## Town of Ledyard

### Juliet W. Long HVAC Improvements

#### Change Order Packet

**PROJECT:** *(Name and address)*  
 2023-121A Juliet W. Long School - HVAC  
 Project  
 1854 CT-12  
 Gales Ferry (Ledyard), CT 06335

**PROJECT:**  
**ENGINEER:**  
**DESCRIPTION:** Steel Louvered Filter Grille  
530FF-1-1/1/18.000/18.000/SM/F/0/0/L/HT/QTR-TURN/1/B12

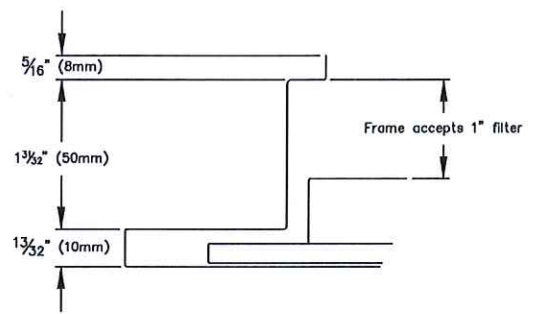
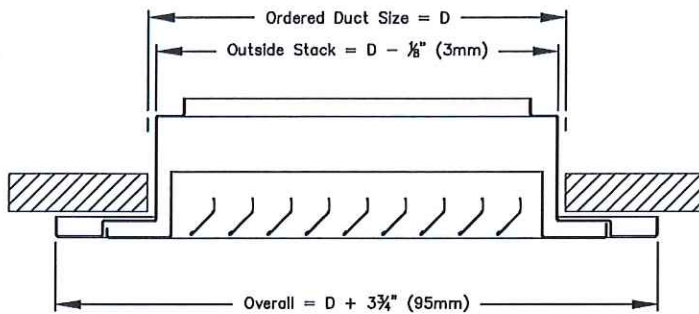
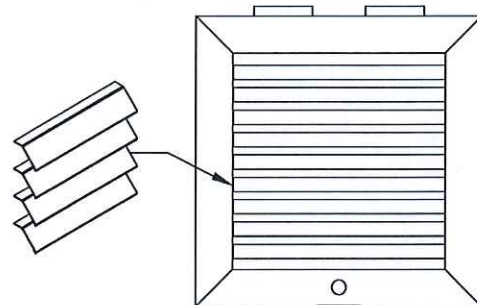
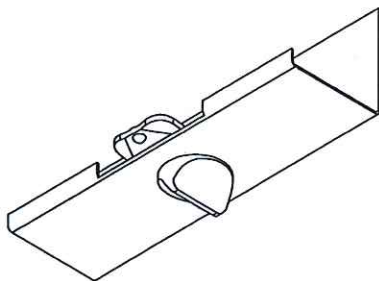
Below please find material and labor pricing to demolition and then fabricate and install new galvanized duct riser which is located in the storage room to allow space for the new electrical work. This work also includes revising the existing duct work below the riser in the crawl space and installing two new 18" x 18" filter grilles on the existing duct in the crawl space.

Includes Galvanized Steel Duct and Accessories and  
Filter Grilles (See attached submittal for the basement grilles) \$862.00

**DRAWING TITLE:**  
**ELECTRICAL  
SCHEDULES AND ONE-  
LINE RISER DIAGRAM**

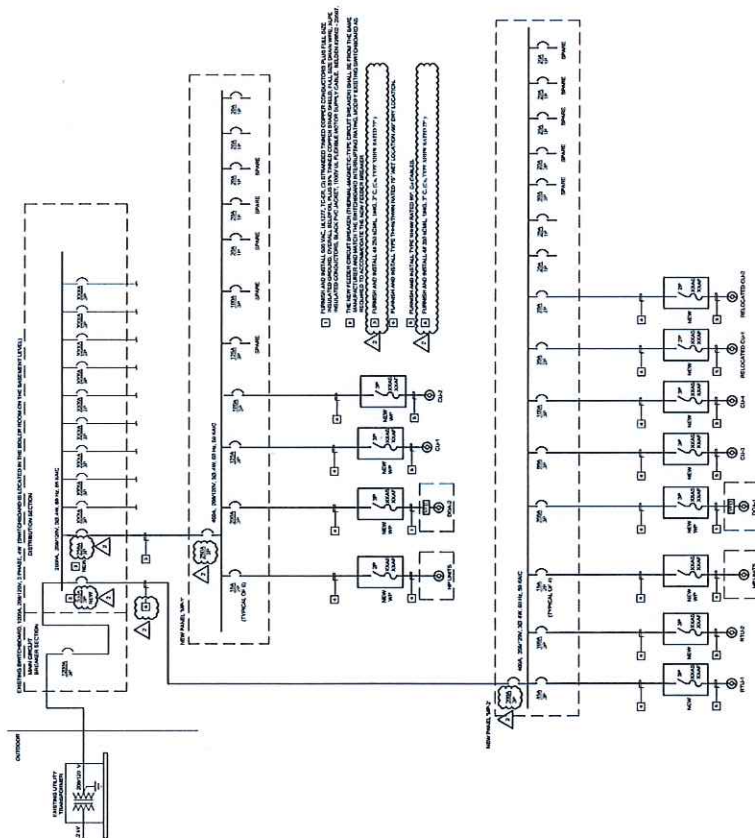
Electical Changes per Bulletin #1r1 for splitting panels by north/ south wings.

PARTIAL FLOOR PLAN  
FLOOR INFILL AT  
CUST.28

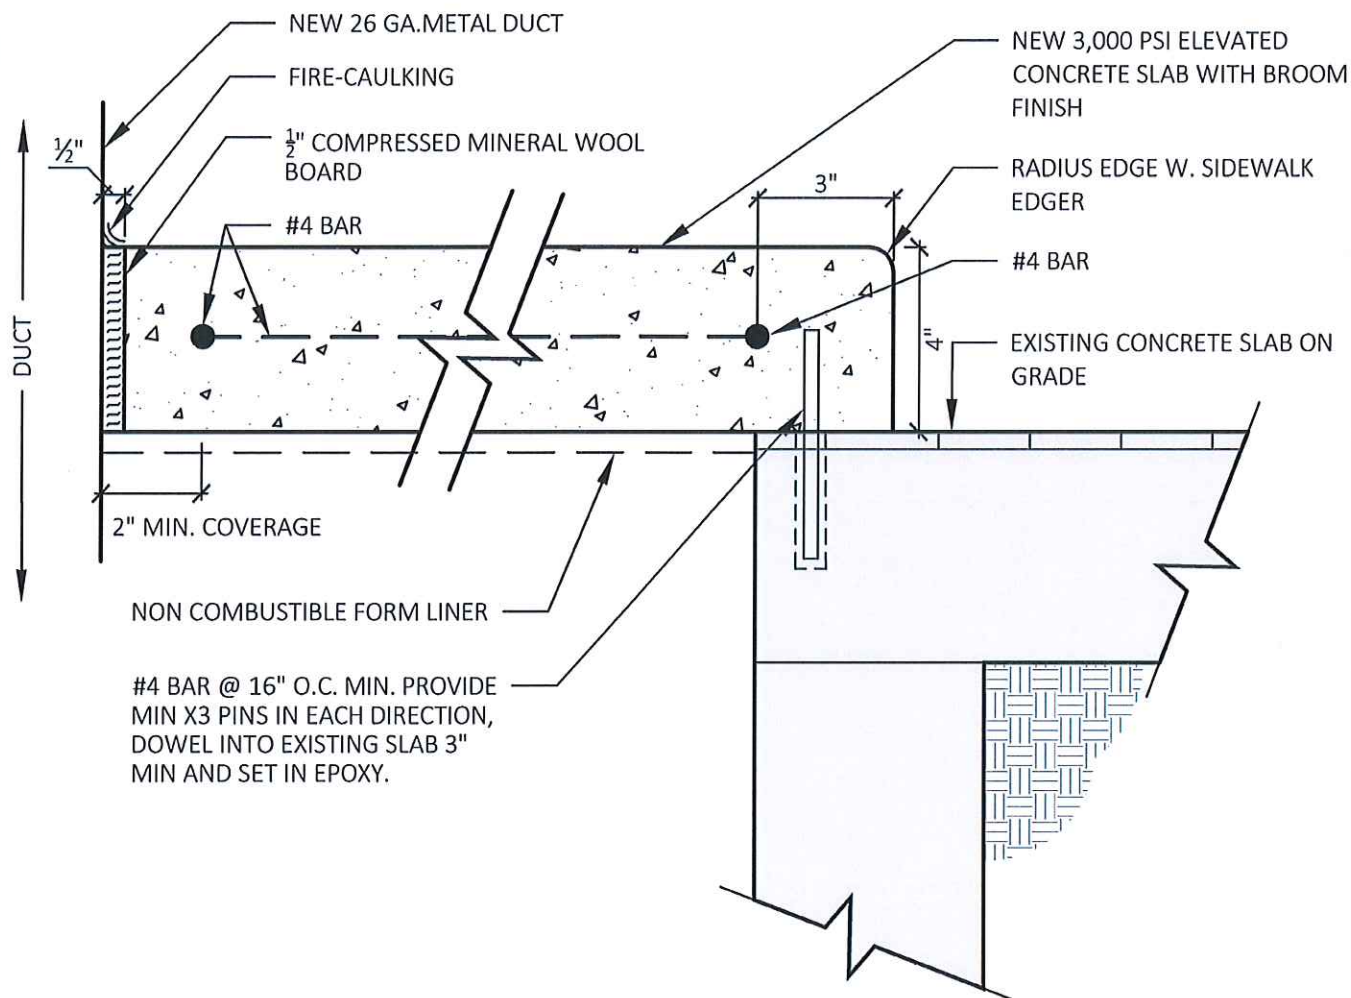
CONCRETE CURB INFILL:

- PROVIDE NEW 4" TALL CURB AND ELEVATED SLAB
- 3000 PSI CONCRETE
- #4 REINFORCING BAR
- BROOM FINISH ON TOP OF SLAB/INFILL

NEW CONDUIT SEAL, W/ FIRE  
CAULK

PIN TO WALL W/ #4 BAR,  
EPOXIES IN.

SEAL ALL SIDES W/ FIRE CAULK,  
SEE SKA-03

NEW 26 GA DUCT V.I.F.
